# Memorandum

**Date:** July 11, 2007  
**To:** Westfield - Washington Township Plan Commission  
**From:** Jon Dobosiewicz, Wilfong Kreutz Land Development  
**Re:** Eagletown PUD:  
Proposed Amendments to Eagletown PUD – Public Hearing held on May 29<sup>th</sup>

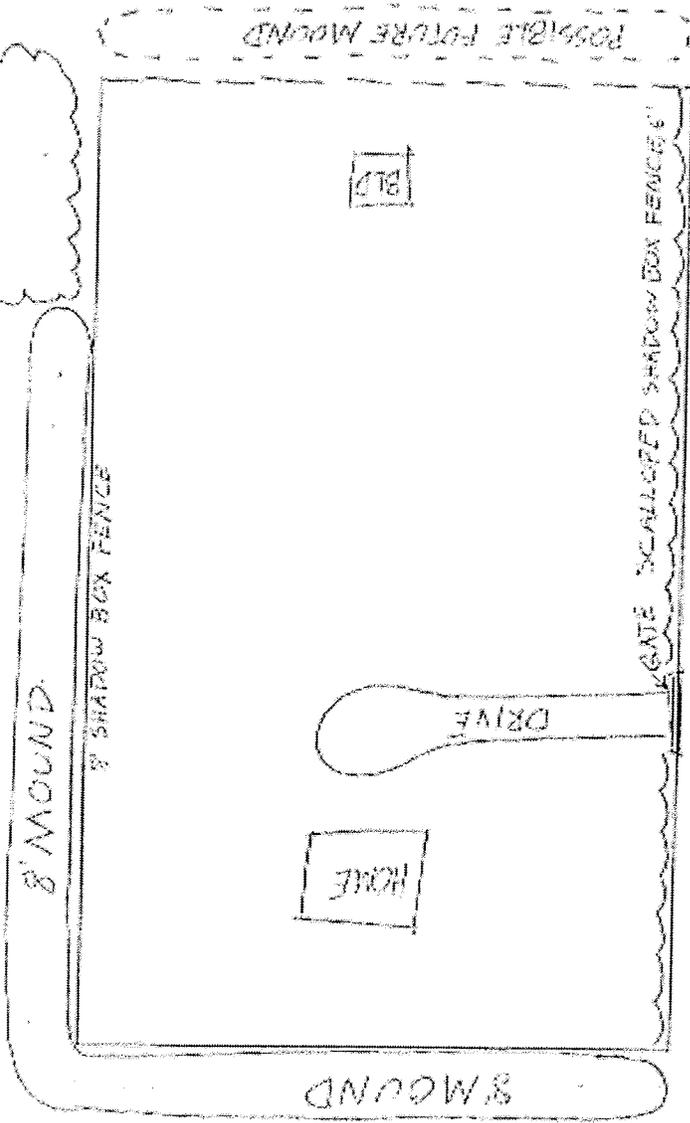
- 8' high mound along the entire western board and along the northern border until the "woods" meets the new mound.
- Mound will be a 2/1 slope on the Markusfeld side and a 2/1 or 3/1 slope on Eagle Station side

- 7 to 8 foot tall Norway Spruce to be planted 11' apart on top of mound.
- Privacy fence along the property line along the west boundary and Northern boundary. This would be an 8 foot "shadow box" type fence

7 to 8' TALL NORWAY SPRUCE

VEGETATION TO KEEP DOWN EROSION & SO NOT COMPETING TREES DON'T GROW WELL

MOUND SIMILAR TO COUNTRYSIDE MOUND ALONG SPRINGMILL ROAD
